HEARING STATEMENT

Policy SB24: Sion Hill, Bath Site Allocation – Hearing Statement

- 1.1 Context Planning Ltd have been instructed to prepare this hearing statement on behalf of the Bath Preservation Trust (BPT). This statement responds to the Inspector's initial matters, issues and questions (EXAM 4), in particular Q.33 and Q.34 and should be read in conjunction with BPT's earlier representations.

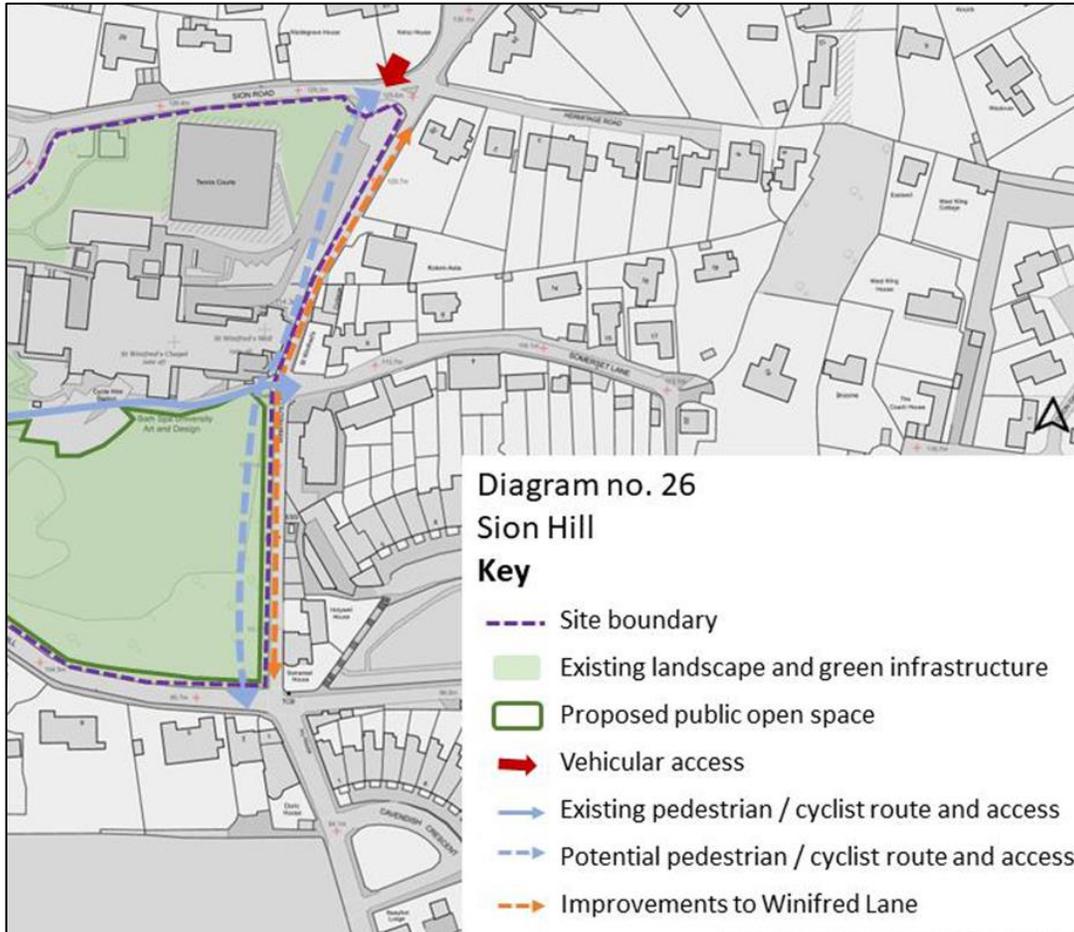
- 1.36** Criteria 9 and 10 of the policy set out a number of measures to enhance the site's walking and cycling opportunities. The supporting concept diagram indicates a potential pedestrian/cycle route through the site along the eastern boundary in parallel to Winifred Lane, which is expected to be linked to the wider walking and cycling network (see below).

- 1.37** The preliminary indication of the route however appears to be problematic in relation to the group of mature trees and planting concentrated at the south-east corner of the site. Placing the pass further into the site to avoid harm to boundary planting would make it less obvious to the walkers/cyclists and less attractive in respect of 'desire lines' as it will require a detour from the direct link along Winifred Lane.

- 1.38** Provision of a segregated route also effectively enables the ongoing use of Winifred Lane as a through route for traffic seeking to shortcut to the top of Lansdown. The requirement for options 'to be investigated' to reduce traffic flows and speeds along Winifred's Lane should be strengthened to reduce the associated risk to highway safety.
